LIBERTY TREE ACADEMY
DRAFT PRELIMINARY DRAINAGE REPORT

PPR-18-023

Subject: Delete
Page Label: 16
Author: dsdrice
Date: 6/14/2018 10:31:36 AM
Color: ■

FIGURE A-2. PROPOSED DRAINAGE PLAN

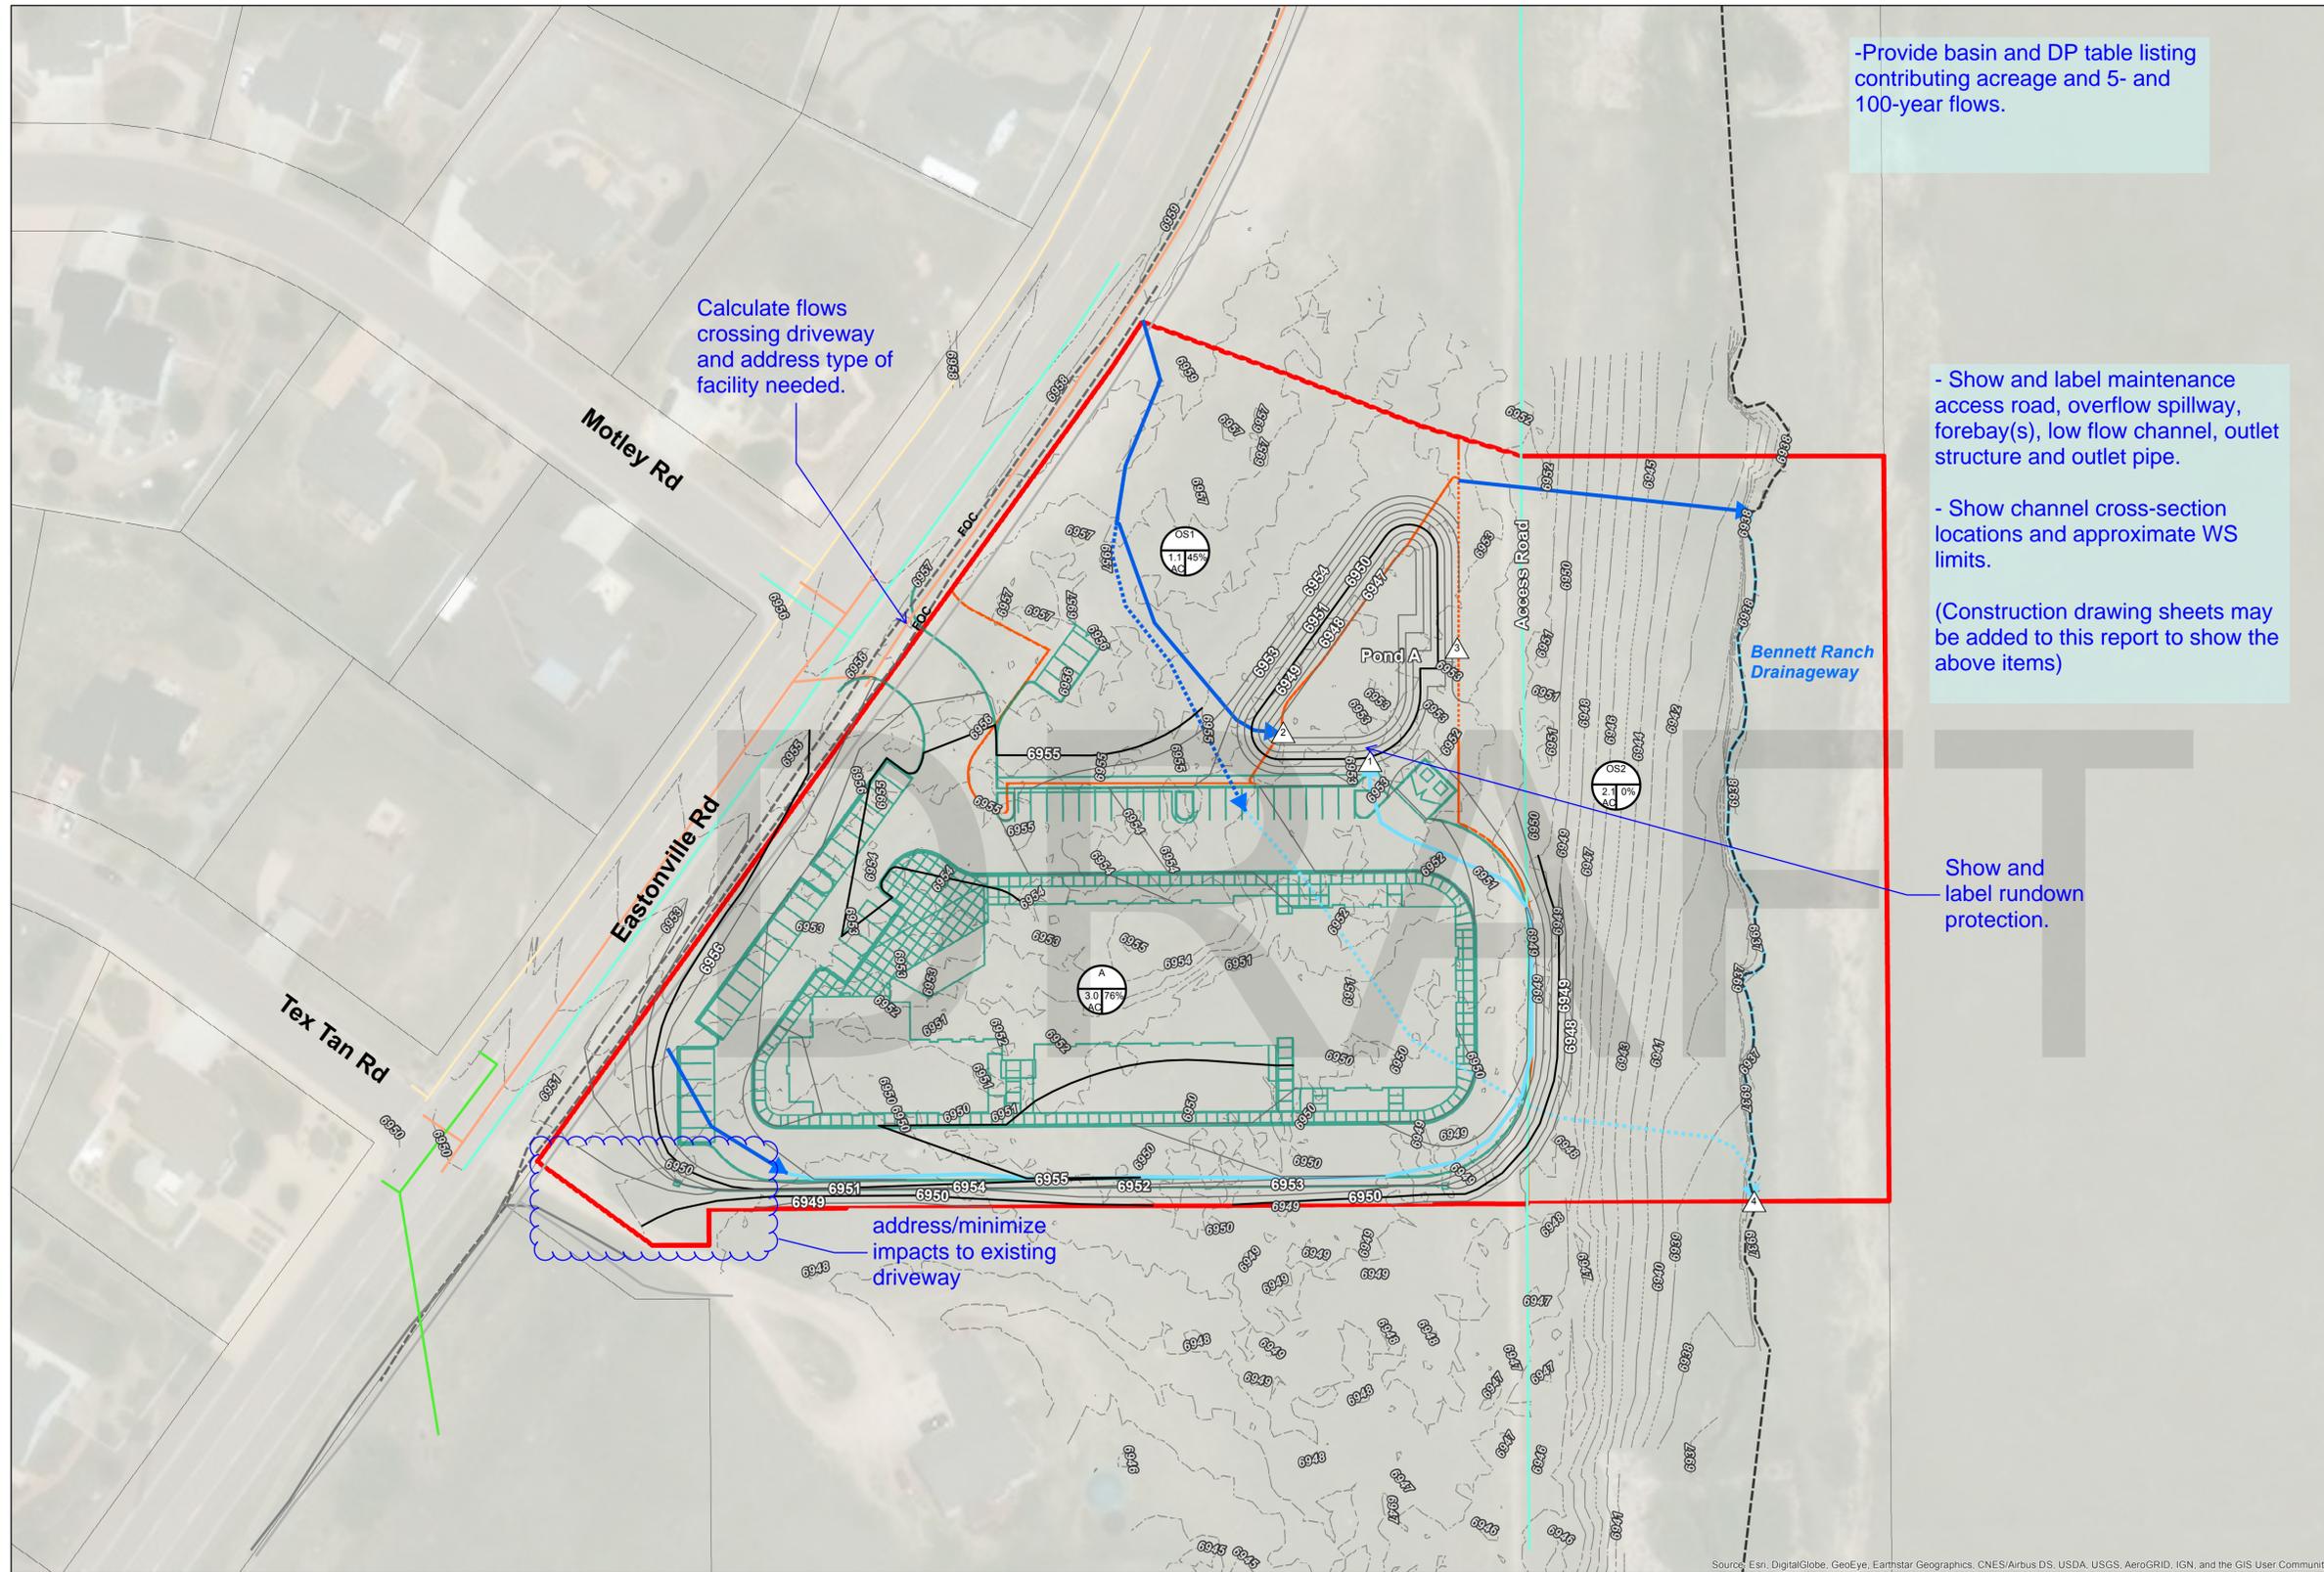
Provide Existing
Drainage Plan
